Burlington Design Advisory Board

DESIGN ADVISORY BOARD Tuesday, September 13, 2022 3:00 PM

MEMORANDUM

To: The Design Advisory Board
From: Mary O'Neil, AICP, Principal Planner
RE: 45-47 Lakeside Avenue ZP-22-485
Date: September 13, 2022

Proposed
Plot Plan

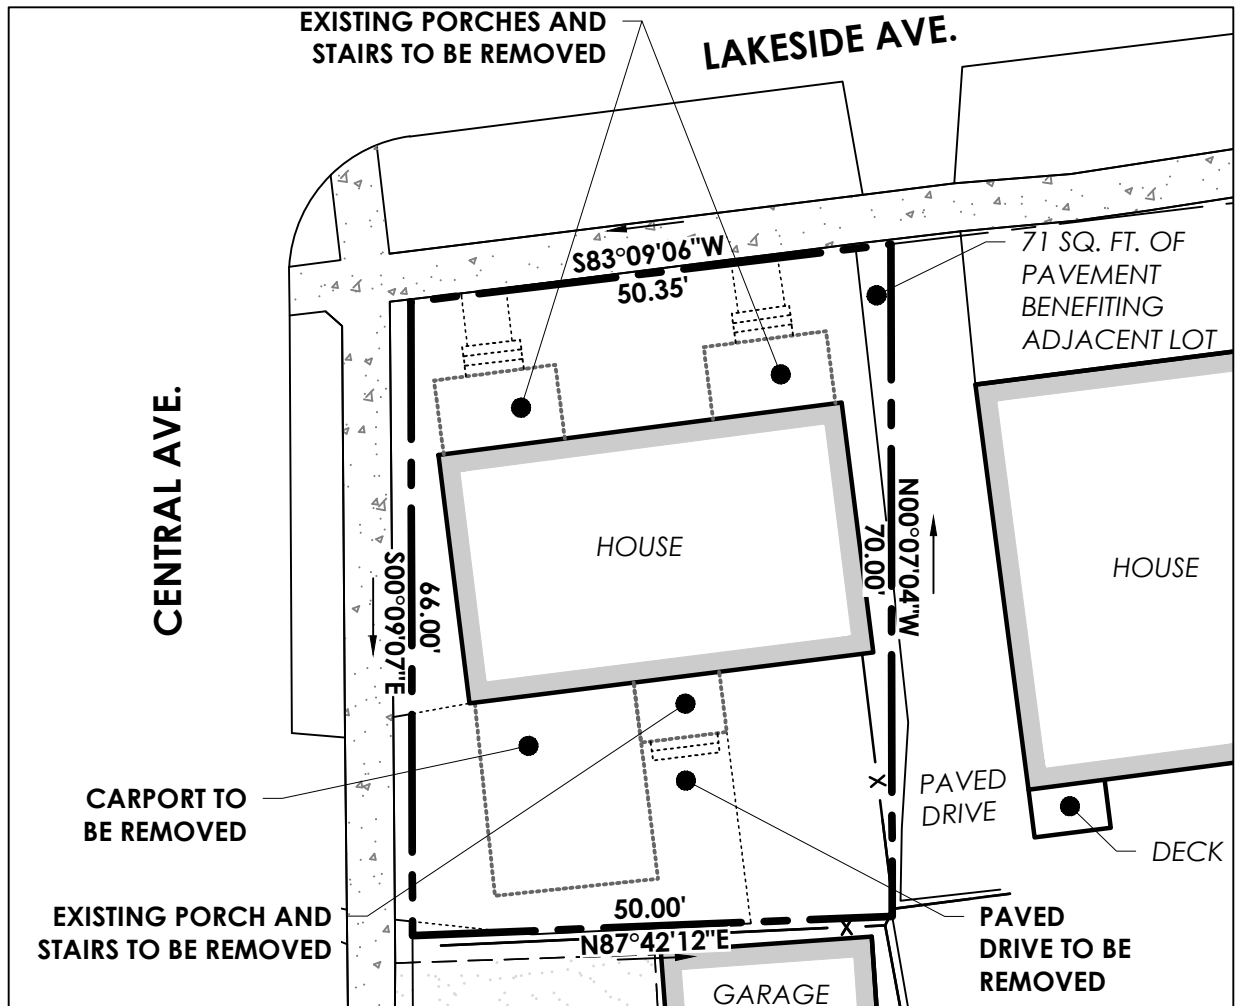
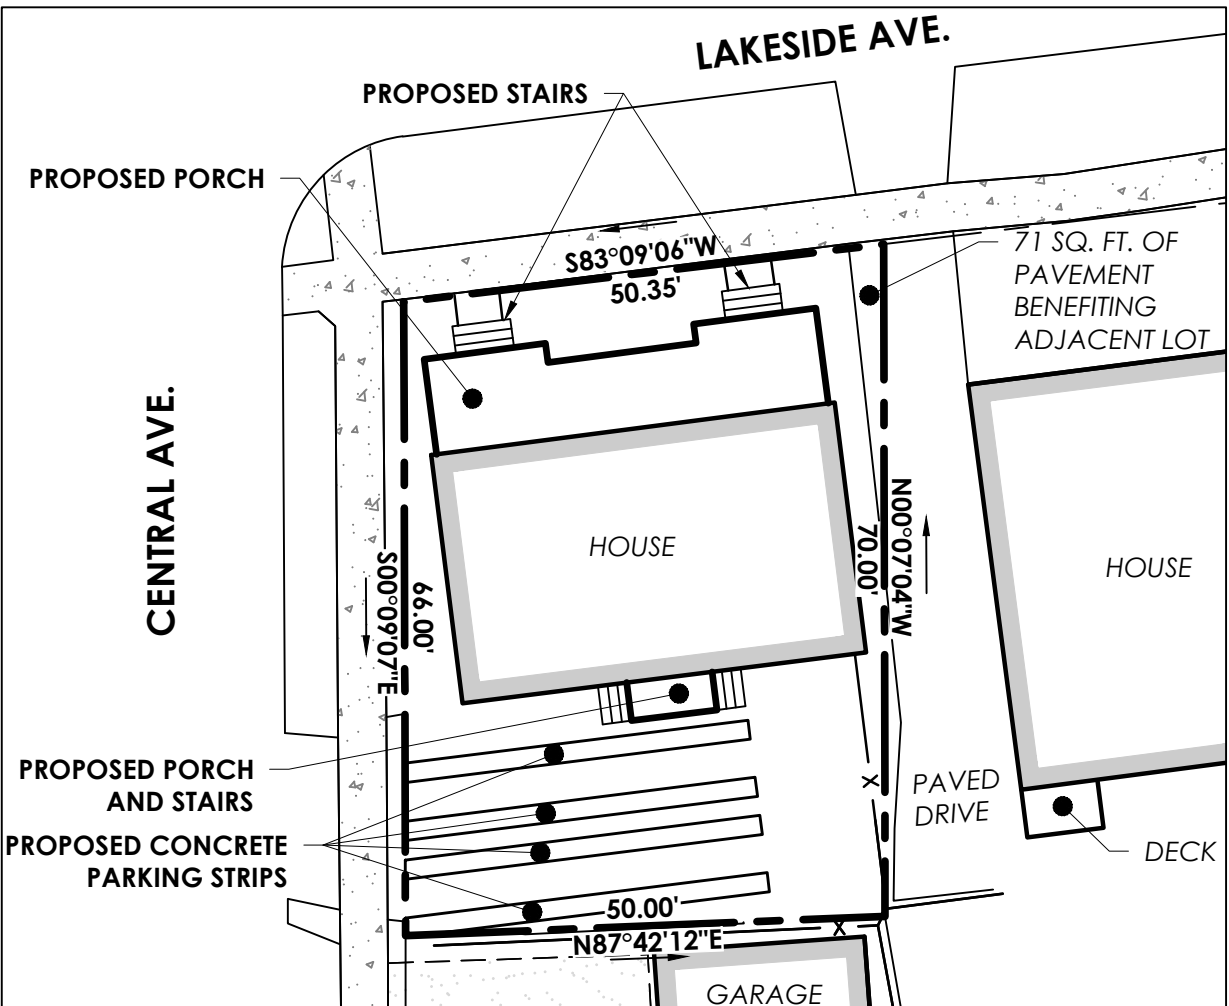
The application proposes removal of the dual porches and the carport, with the installation of dual pair of tire paths to accommodate the proposed increase in lot coverage introduced by the enlarged front porch. The carport is not historic; and any effort to reduce lot coverage without altering the character of the structure is encouraged.

- Lot coverage is still calculated where vehicles are parked, so a revision must be made to the plans (dimensional measurements needed) to correctly calculate what, if any, diminishment of lot coverage may occur with the removal of the asphalt. The carport is not historic.
- The removal of dual front porches and replacement with a connected porch introduces a conjectural feature inconsistent with the time period of the construction of this Colonial Revival duplex; and diminishes the historic integrity of this structure and the overall historic district.
